Design Exception #4 Reducing the Roadway Median Width

**I-70 West Vail Pass Safety and
Operations Improvements**

DESIGN EXCEPTIONS MEETING # 3
AUGUST 2, 2021

PROJECT LEADERSHIP TEAM MEETING # 9
AUGUST 6, 2021

Exhibit C (1 of 3)-
Context Sensitive Solution
Median Design Exception
Mile Post 188.8 to 190
07-20-2021

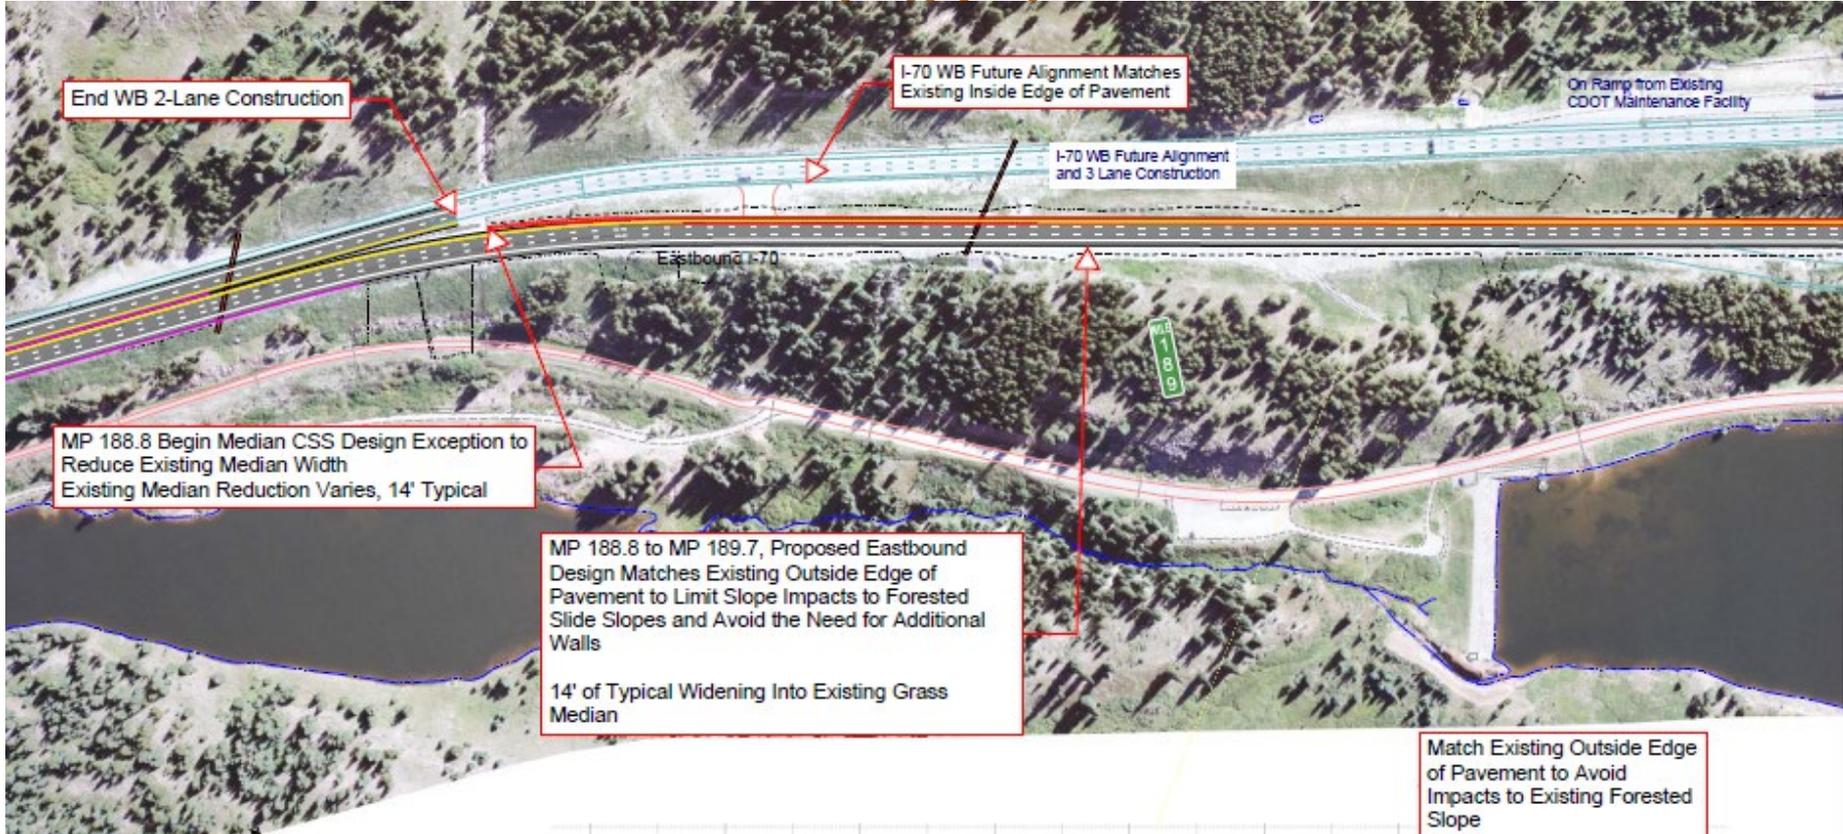
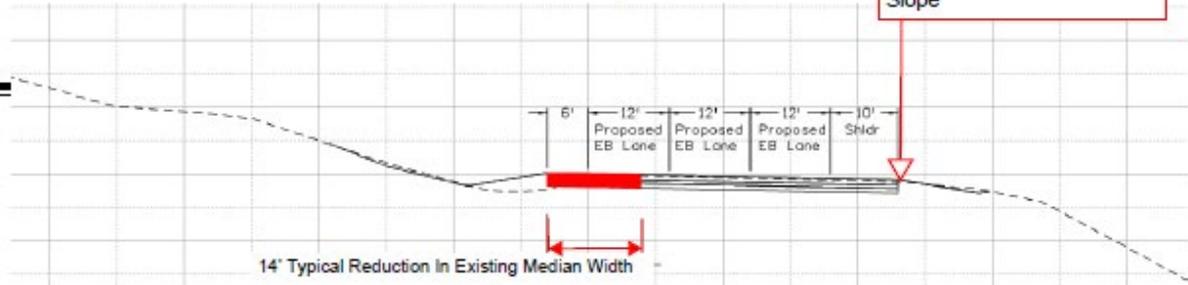
- iii. The third design exception is from MP 188.0 to MP 190.1. In this area we are holding the southern edge of pavement and widening into the median. It protects the slope, and the forested areas and we didn't want to get any closer to Black Lake. John said it will leave room for water quality features on the south side in those areas where we are still refining and designing right now. There is also another wildlife crossing that is in the area.

As we move farther long, if we push the roadway further south it generates larger and larger walls for the future truck parking expansion and push it farther into the forested area. Widening into the median helps to reduce that. John said they met with the Forest Service extensively throughout this process and they don't want us to encroach onto Black Lakes Road because that's currently where they have all their winter recreation parking. They park there for the summer as well, but it doesn't fill up as much. They wanted us to stay away from there for snow storage and to make sure they don't lose any parking.
